ADDENDUM

AM 04

PROJECT : Forestside
PROJECT # : 1331.15
DATE : August 24, 2020

Title: Updated drawings

1:100 A401

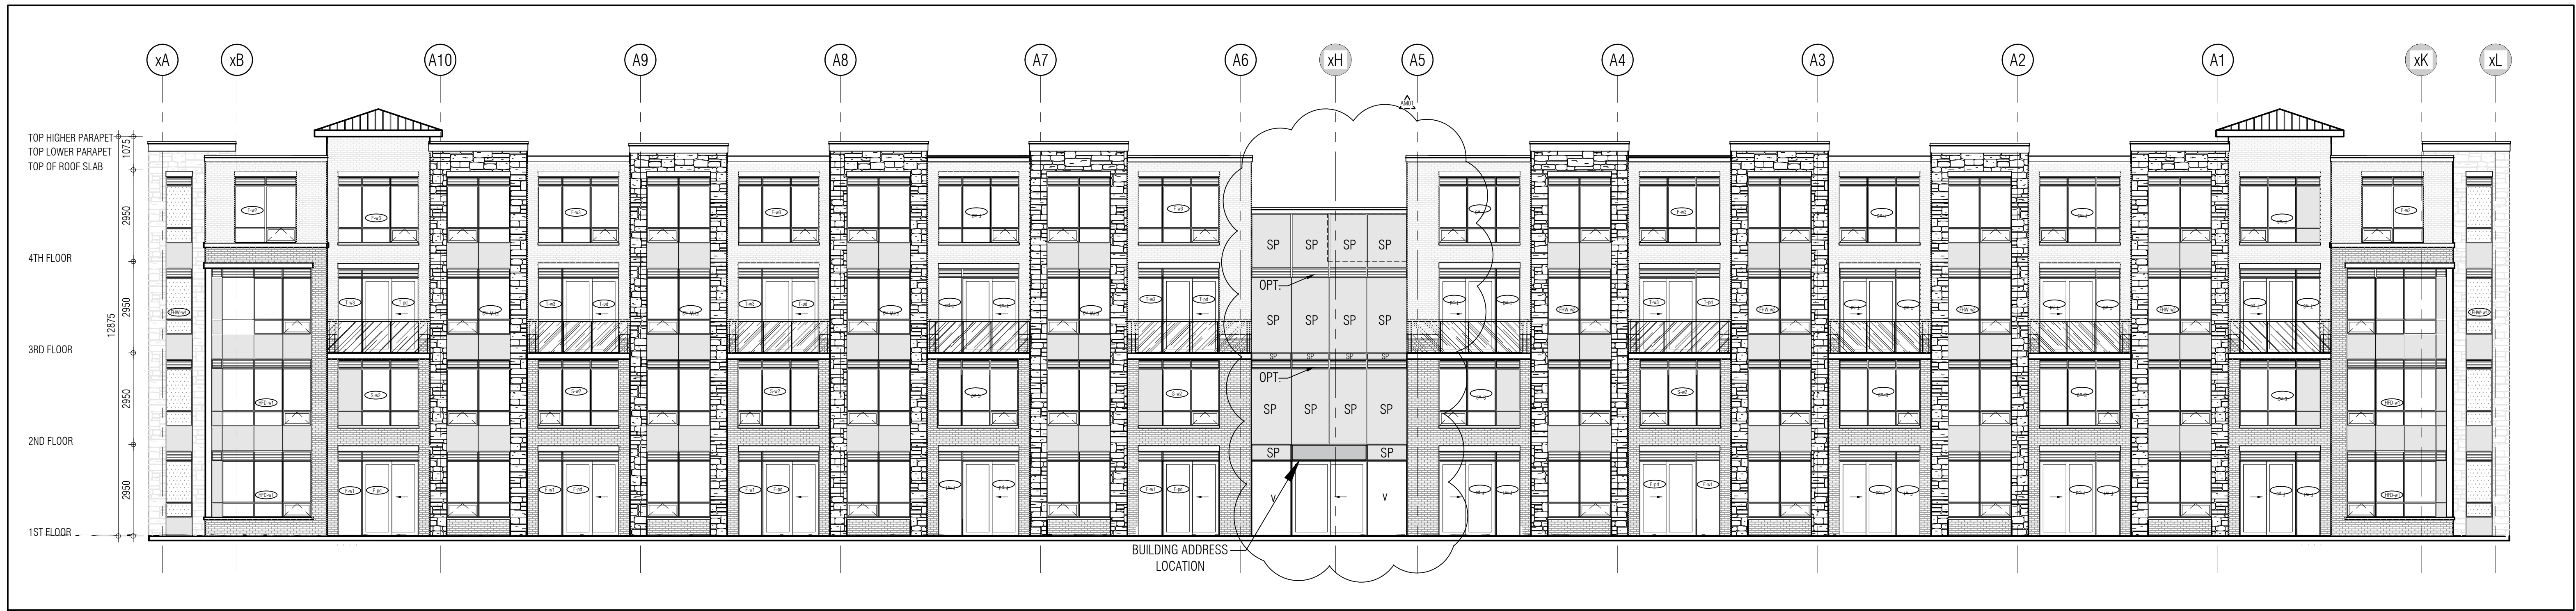
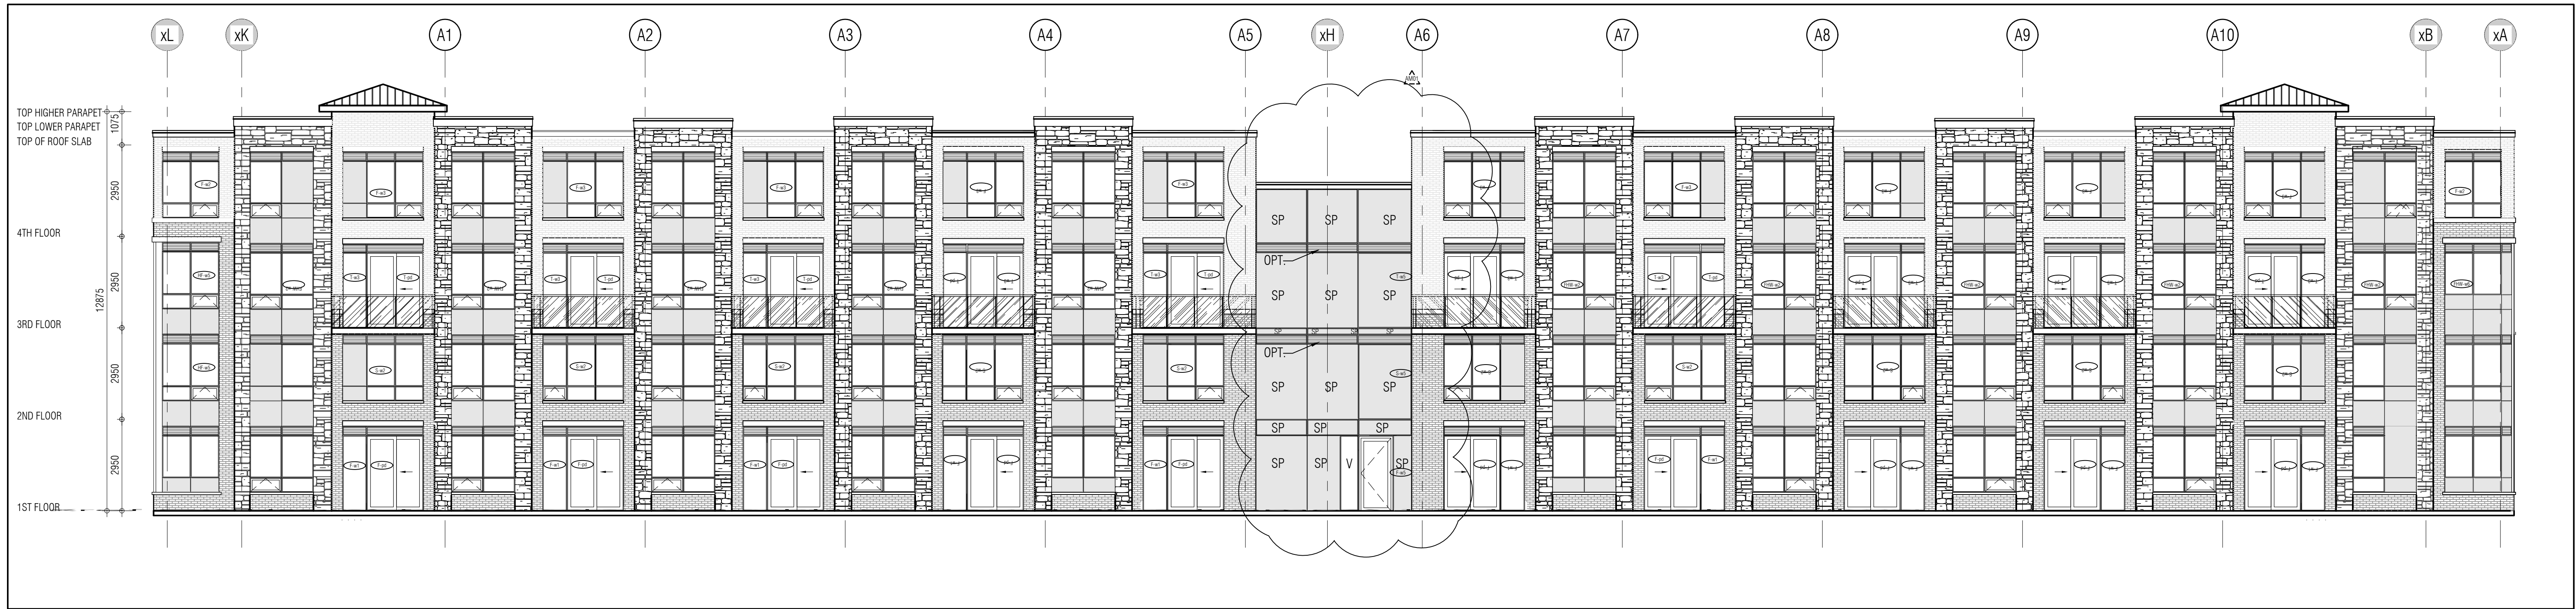
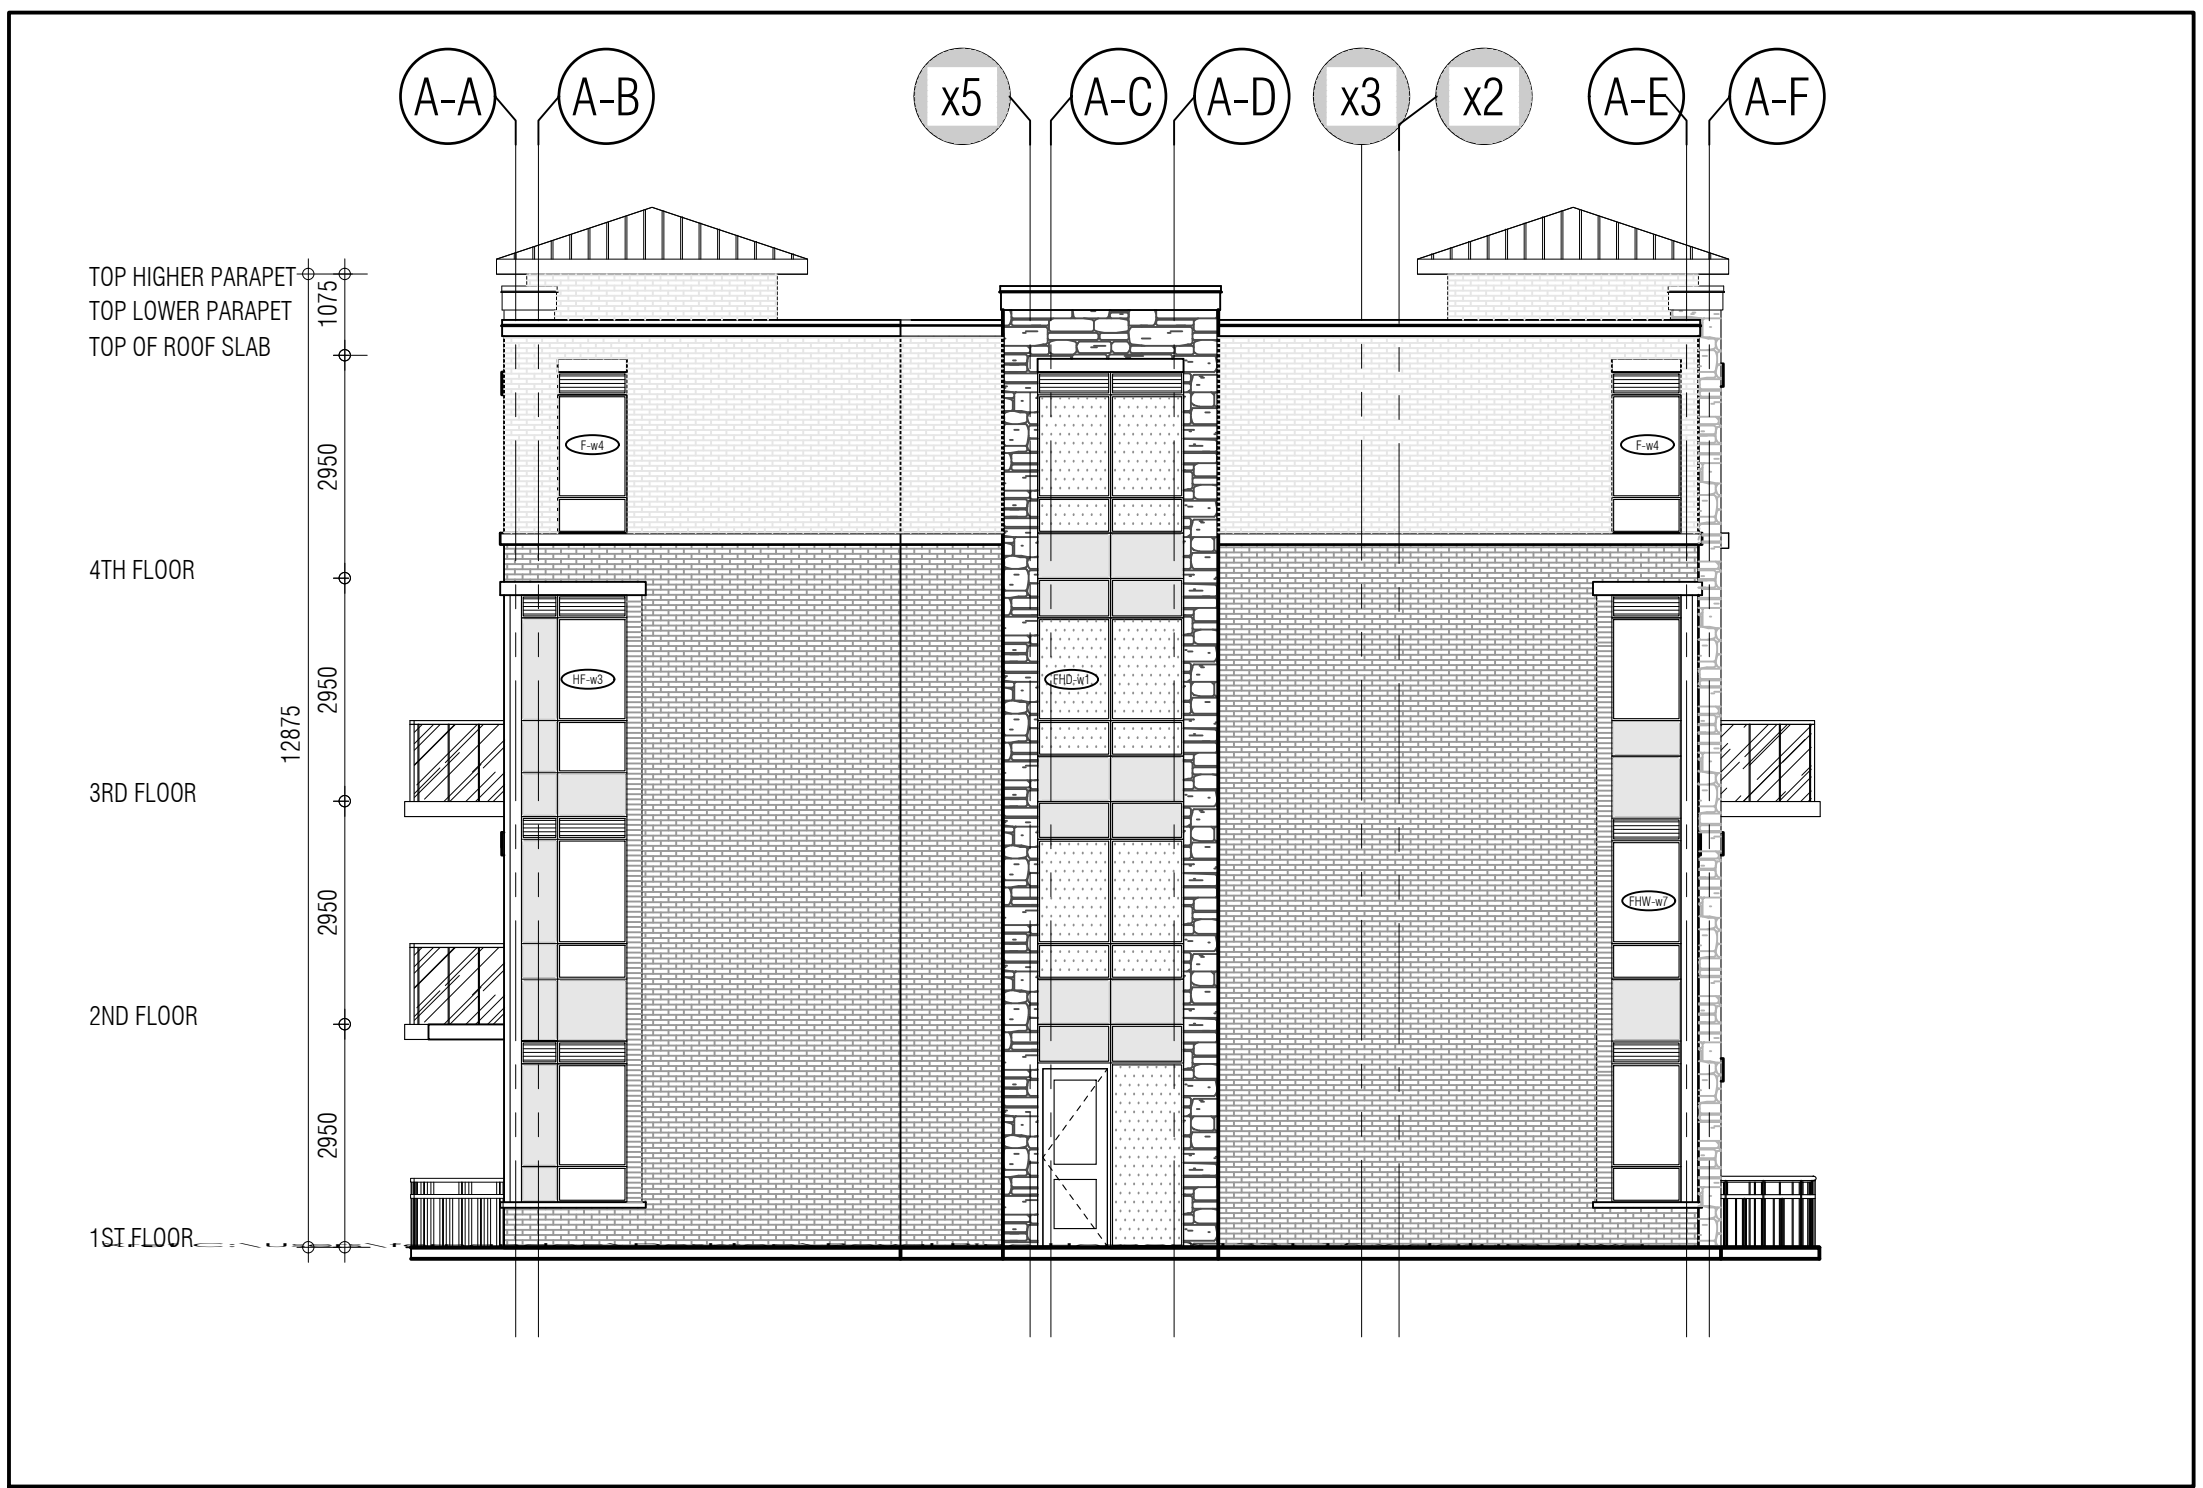
Reference:		Changes:
A-102	Wall Schedule	Revised Insulation and Sheathing on Exterior Brick, Stone, Concrete and Concrete Block walls to Spray Foam Insulation and Securock (CGC) Sheathing.
A-401 A-402 A-403 A-404	Building A Elevations Building B Elevations Building C Elevations Building D Elevations	Revised Key Plan Legend to match block elevation designation.
A-500	Building Sections	Revised all sections elevations to match updated exterior wall changes above.
A-600	Wall Sections	- Revised all wall sections to match updated exterior wall changes above. - Revised shelf angle location to be between suites on 3rd and 4th floor where it is one suite to act as Firestop and Added Firestop to floors in between suites at lower levels that do not require shelf angle.
A-900	Section Details	Revised all wall sections to match updated exterior wall changes above.
